# SADDLEHORN RANCH FILING NO. 2

**PCD FILE: SF-21-033**

JOB NO. 25142.04  
DECEMBER 8, 2022  
SHEET 1 OF 5

# v5\_Final Plat Drawings.pdf Markup Summary

JOB NO. 25142.04  
DECEMBER 8, 2022  
SHEET 3 OF 5

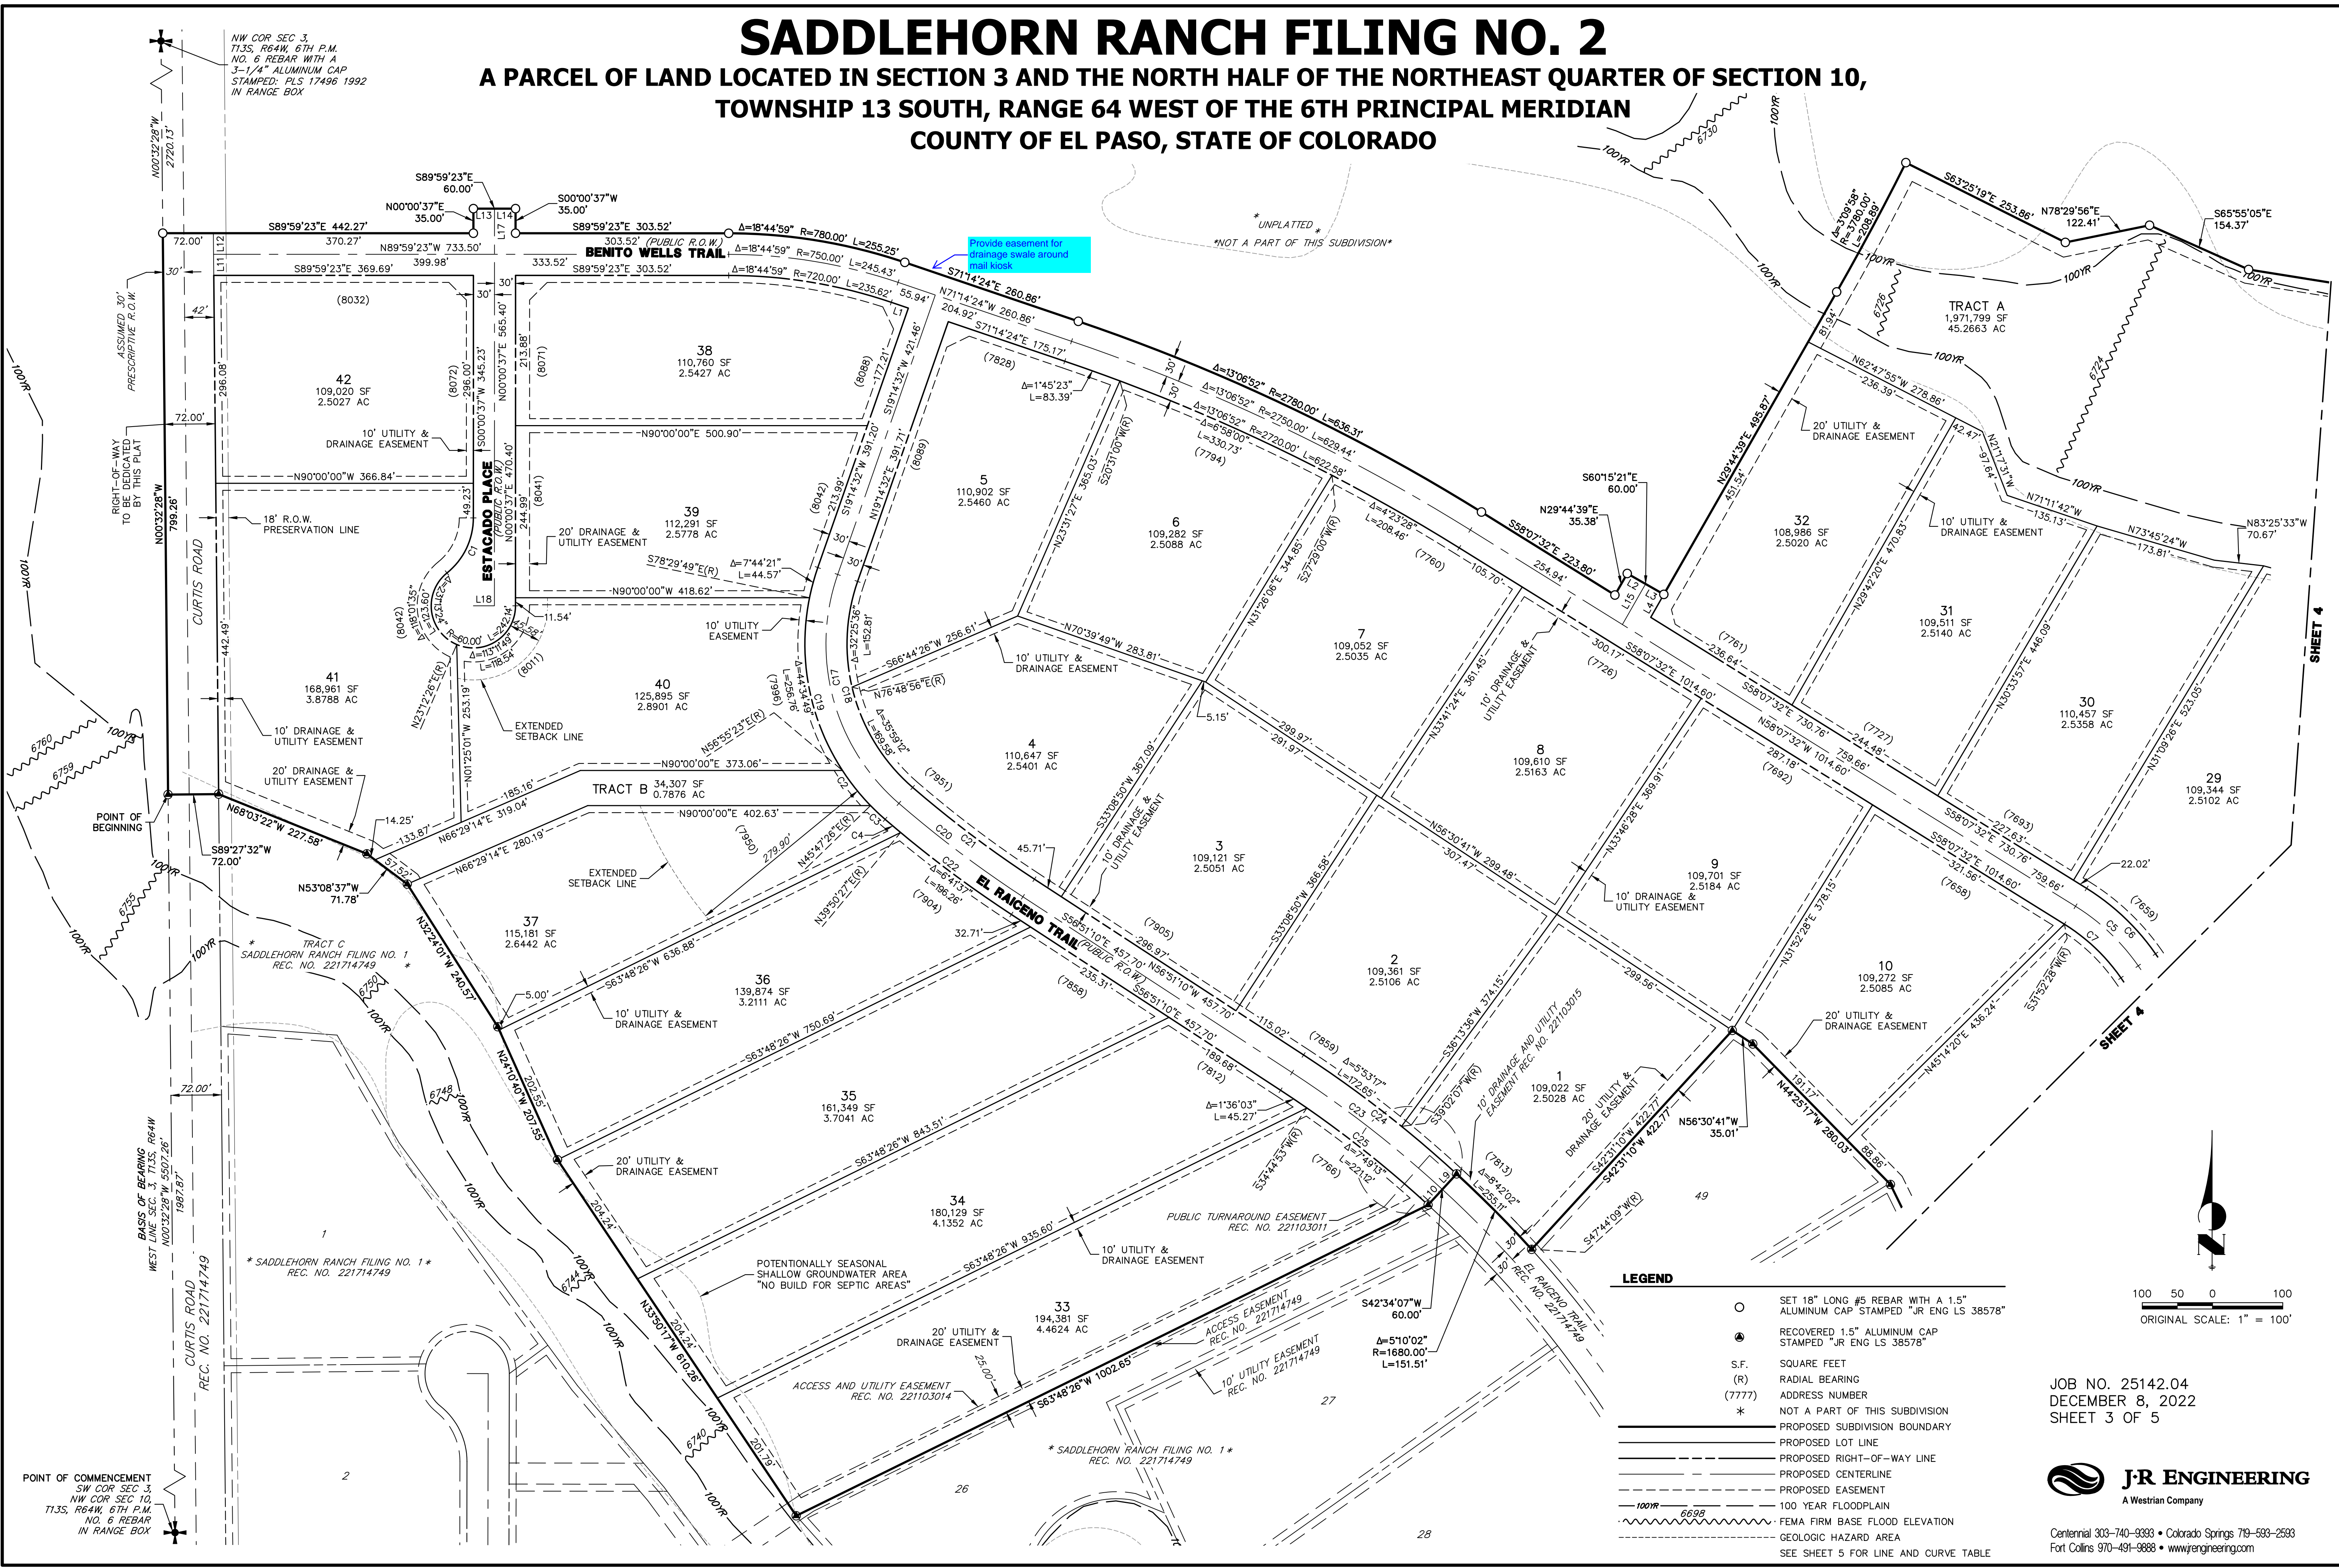
Provide easement for  
drainage swale around  
mail hook

Provide easement for drainage swale around mail kiosk
